ECK 9TH ADDITION SEDGWICK COUNTY, KANSAS

RE: SUB 2001-68 -- Final Plat of Eck Ninth Addition

At the regular meeting of the Subdivision Committee of the Metropolitan Area Planning Commission on Thursday, August 30, 2001, the above captioned plat was considered. The action of the Committee was to approve the final plat, subject to the following:

CASE NUMBER: SUB 2001-68 -- ECK NINTH ADDITION

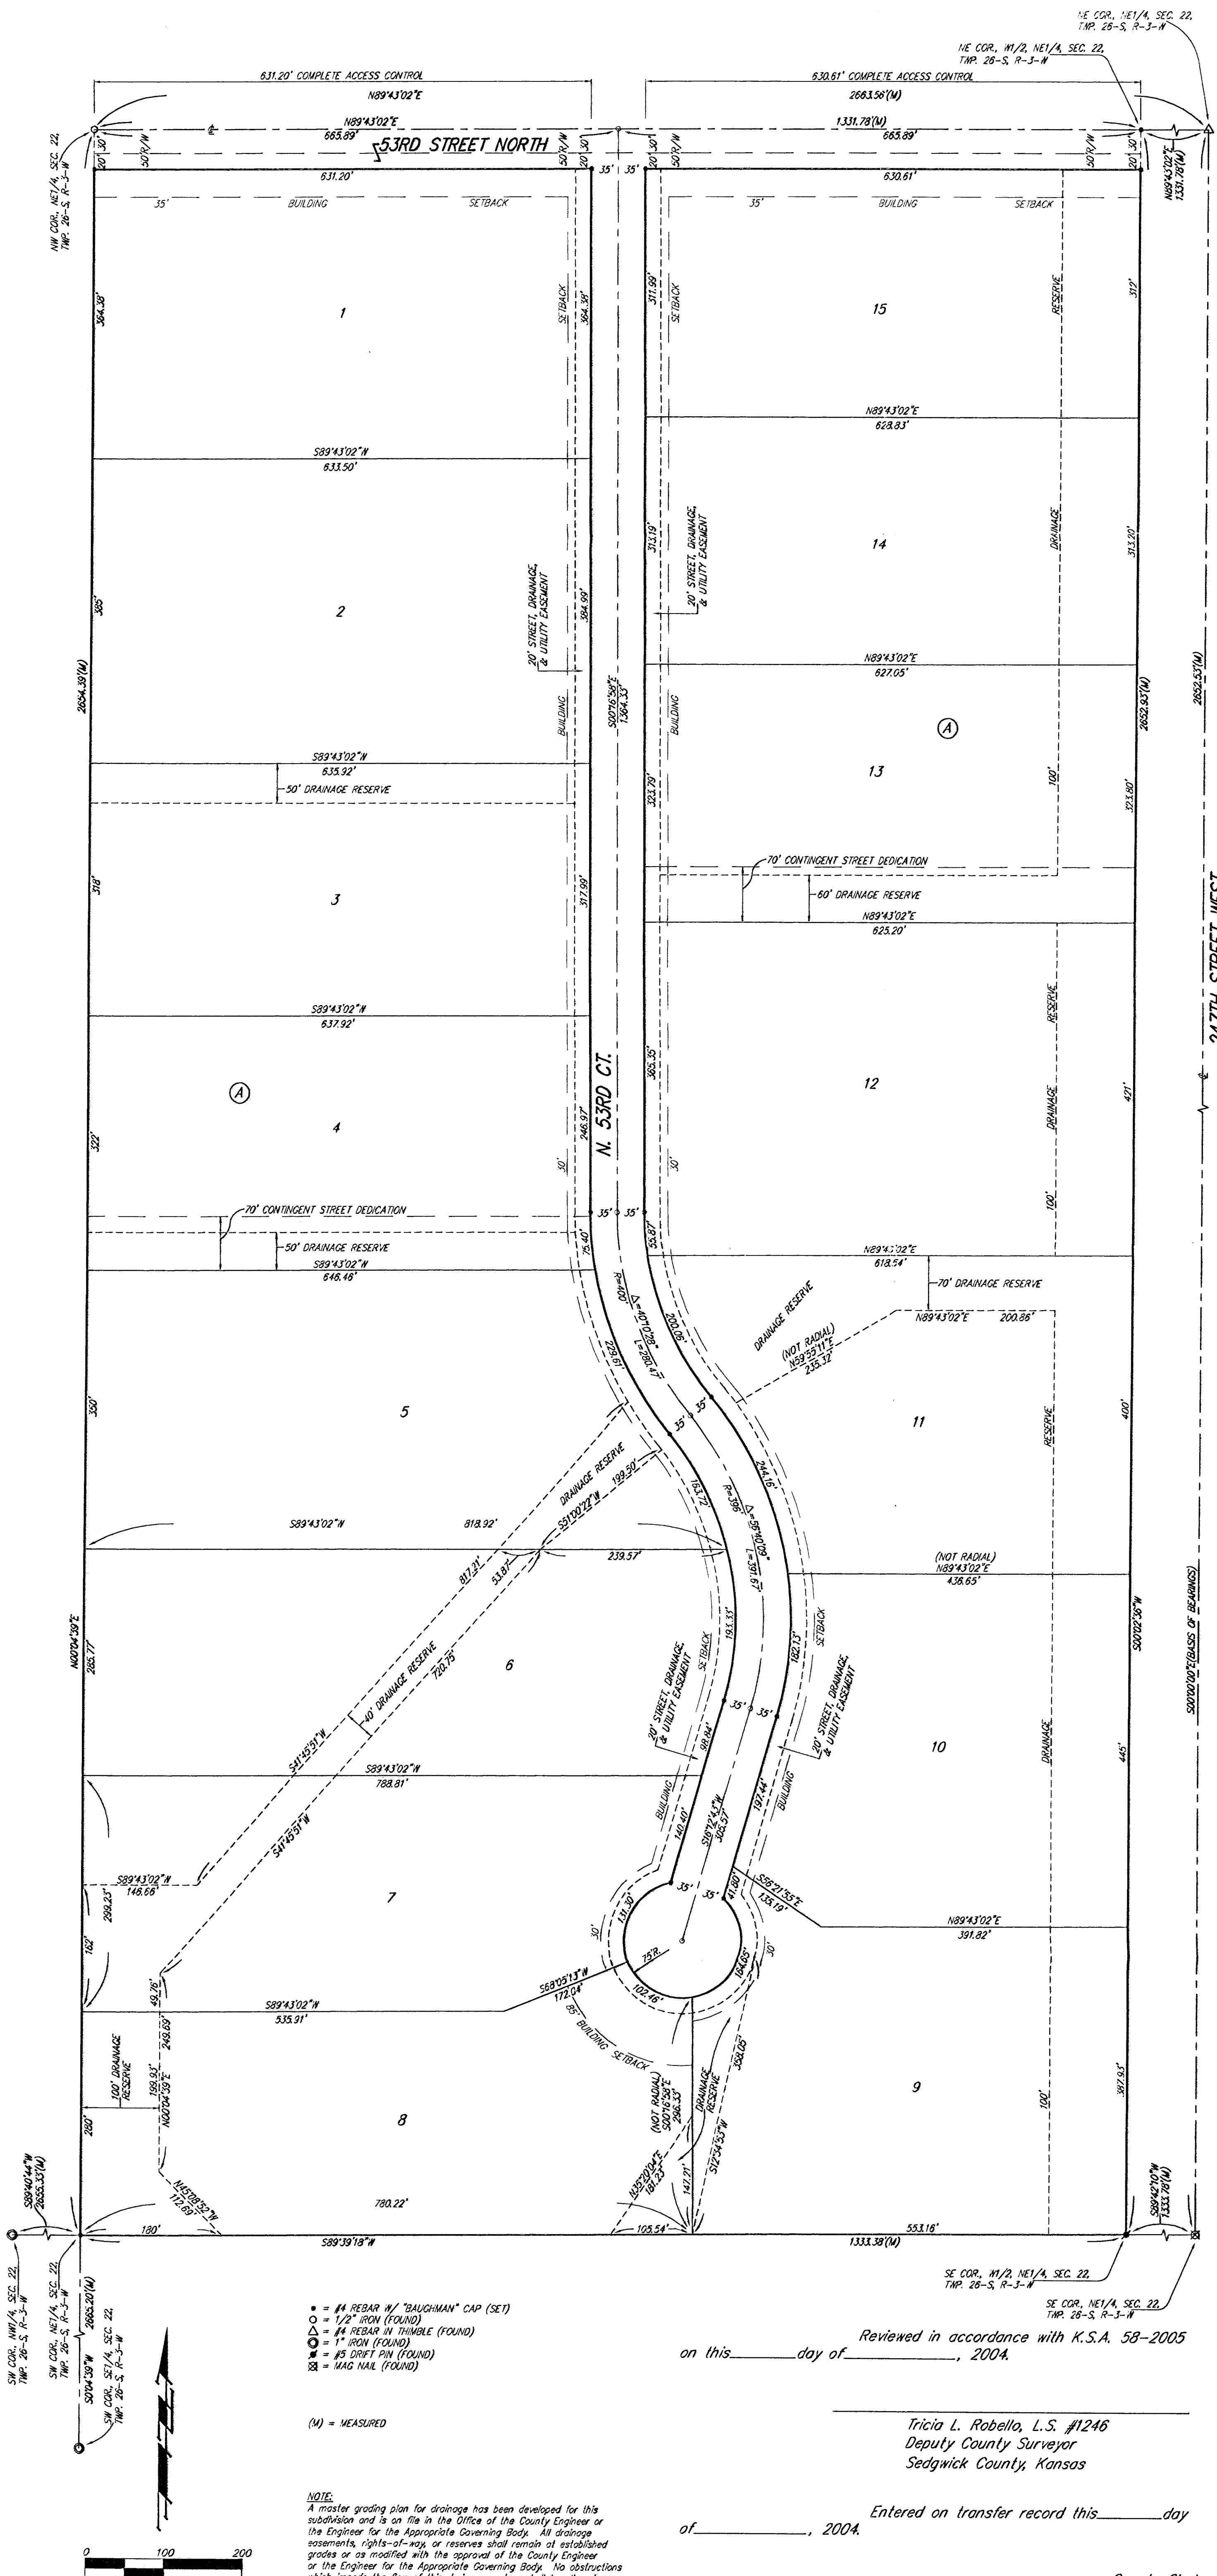
- C. County Engineering needs to comment on the status of the applicant's drainage plan. A detailed final drainage plan is needed and additional drainage reserves are required. A lot grading plan is also needed.

- D. County Fire Department needs to comment on the street length of 53rd St. . Ct., which is 2,100 feet exceeding the 1,200-ft limitation of the Subdivision Regulations. The street length is approved contingent upon the installation of a 36-ft wide rock road and contingent street right-of-way dedication to the east and west. The Subdivision Committee has approved a modification.

- F. County Engineering has required a 70-ft contingent dedication of street right-of-way extending to the east and west line of the plat in order to provide potential street connection to adjoining properties. The plat's text needs to be revised to reference Lots 3, 4, 13 and 14, Block A.
- G. The County Fire Department needs to comment on the plat's street names. *The street name needs to be revised to N. 53rd Ct.*

- I. Lots 8 and 9 have been platted with increased setbacks in order to conform with the 200-ft lot width standard which is measured at the building setback line.

- J. The plat's text shall include language that a drainage plan has been developed for the plat and that all drainage easements, rights-of-way, or reserves shall remain at established grades or as modified with the approval of the applicable City or County Engineer, and unobstructed to allow for the conveyance of stormwater.

The requested street name has been platted.
